**URGENT MEDICAL DEVICE CORRECTION**  
**Battery Charging Station**  
**Battery is unable to charge in the left bay of Battery Charging Station**  
**Reference Number: OT 1428023**

Datascope Corp., a subsidiary of Getinge, is initiating a voluntary Medical Device Correction on Battery Charging Stations, an accessory to the Cardiosave Intra-Aortic Balloon Pump (IABP).

Figure 1: Cardiosave Lithium-Ion Batteries (A) incompatible with the Battery Charging Station Left Bay and Cardiosave Lithium-Ion Batteries (B) compatible with the Battery Charging Station Left Bay.

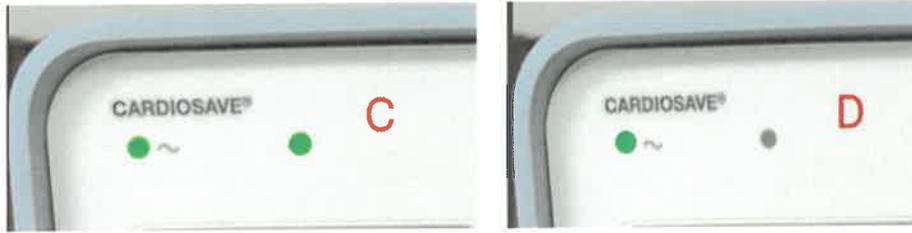
The Battery Charging Station is an optional dual-bay charger used to charge the rechargeable Cardiosave IABP Lithium-Ion batteries when they are not being used to operate the IABP. Getinge has identified that a protruding

screw in the left battery bay limits full insertion of certain batteries and prevents proper charging. The right bay of the Battery Charging Station is not affected by this issue.

The batteries that are not compatible with the left bay of the Battery Charging Station can be identified visually by snapped-in plastic cap inserts (see Figure 1 image below). Distribution of these batteries began in September 2025.

Note: The batteries that do not have the snapped-in inserts can be charged in either bay.

The Battery Charging Station can still be used to charge Cardiosave batteries. Batteries that are **not compatible** with the Battery Charging Station must be charged in the right bay only as described below.

1. Inspect battery(ies) to determine if they are compatible with the left bay of the Battery Charging Station. These batteries can be identified by: snapped-in cap inserts as shown in Figure 1.
2. If the batteries are not compatible with the left battery bay, use only the right charging bay as follows:
  - Insert the battery into the right charging bay
  - Allow the battery to charge completely
  - Remove the battery
  - Insert the next battery requiring charging into the right battery bay
3. Identify if the battery is charging:
  - The Battery Charging Station status LED above the battery slot will flash green while the battery is recognized and charging. If this LED is not illuminated, then the battery has not been recognized and will not charge.
  - During battery charging, the five (5) battery status LEDs on the battery pack will flash sequentially, as displayed below:

- A Getinge representative will contact your facility to schedule a service visit. The protruding screw in the Battery Charging Station will be replaced. The hardware correction will be performed at no cost to your facility.
